## INSPECTORS REPORT ON A LICENCE APPLICATION

Application for a waste Licence from Cemex (ROI) Limited, Killeen Road, Dublin 12, Licence Register No. W0254-01 in relation to a facility at the townlands of Walshestown, Tipperkevin, Bawnogue and Blackhall.

Figure 3: Landfill Cells

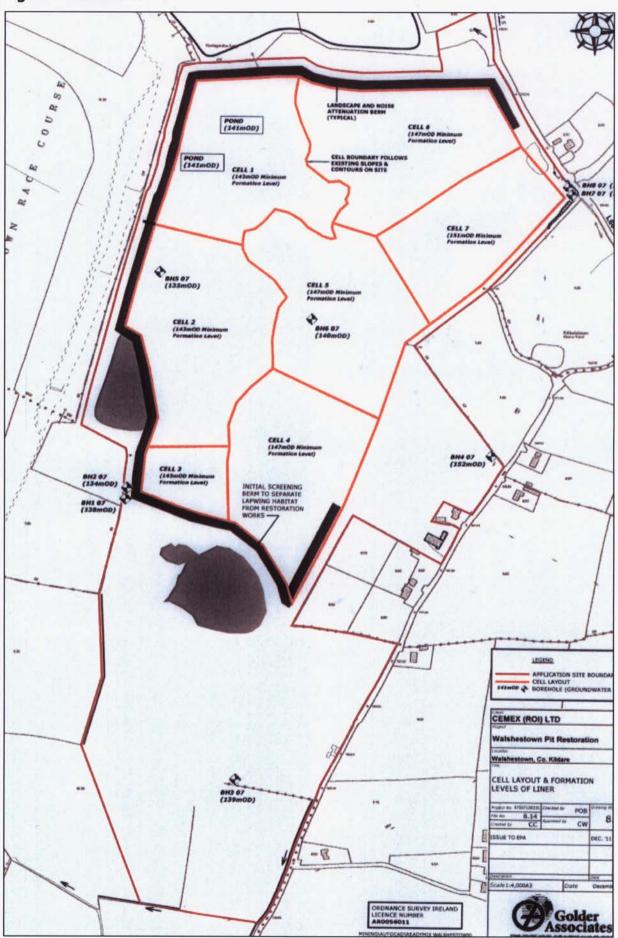
Once the above steps are complete, the liner system will be constructed along the western boundary (Cells 1, 2 and 3). At all times, a liner system will be in place prior to the placement of inert waste. A total of seven cells will be constructed at the facility (Figure 3).

Figure 4: Development steps for the New Water Feature

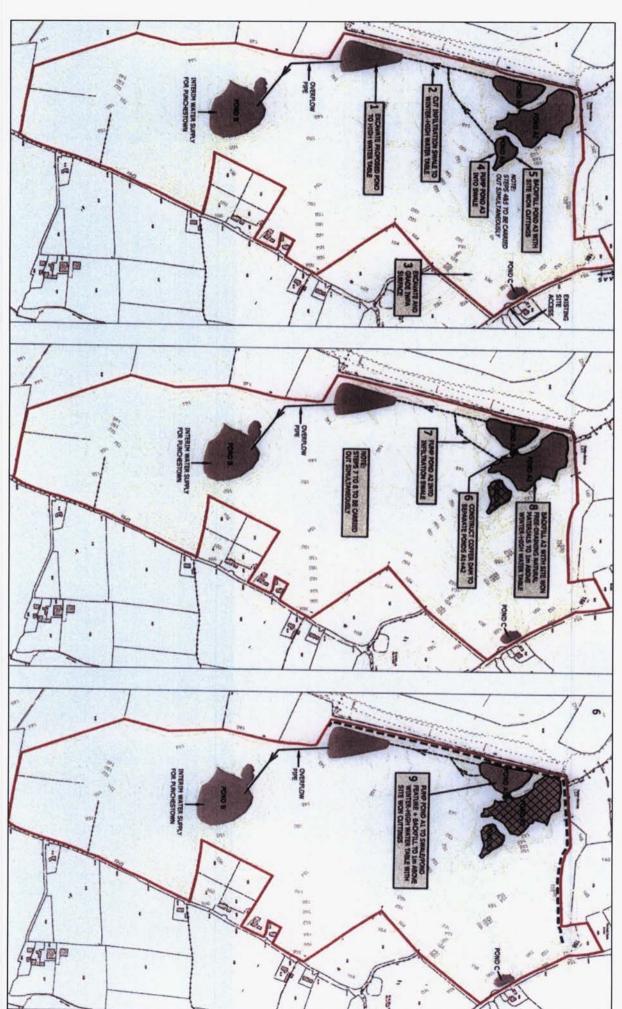
The landfill construction works will incorporate the management of the existing pond water and will comprise of the following steps, illustrated broadly in Figure 4:

- A so-called 'new water feature' (referred to as new pond hereafter) will be excavated into the water table mid-way along the western boundary of the site in order to store water from the pumping out of Ponds A1, A2 and A3. This new water feature will also serve as a receptor for surface water after the landfill is completed.

- 2) When the new pond is excavated an infiltration swale will be cut (through native soils and down to beneath winter-high water table) southward along the western boundary to connect ponds A1 and A2 with the new pond.

- Pond A3 will be pumped out into the infiltration swale and backfilled with native sitewon free-draining natural materials to an elevation 1 m above winter-high water table (approximately 142 m Ordnance Datum (OD)).

- 4) Pond A2 will be pumped out into the infiltration swale and backfilled with native sitewon free-draining natural materials to an elevation 1m above winter-high water table.

- 5) Pond A1 will be pumped out to the infiltration and backfilled in the same manner as Ponds A3 and A2.
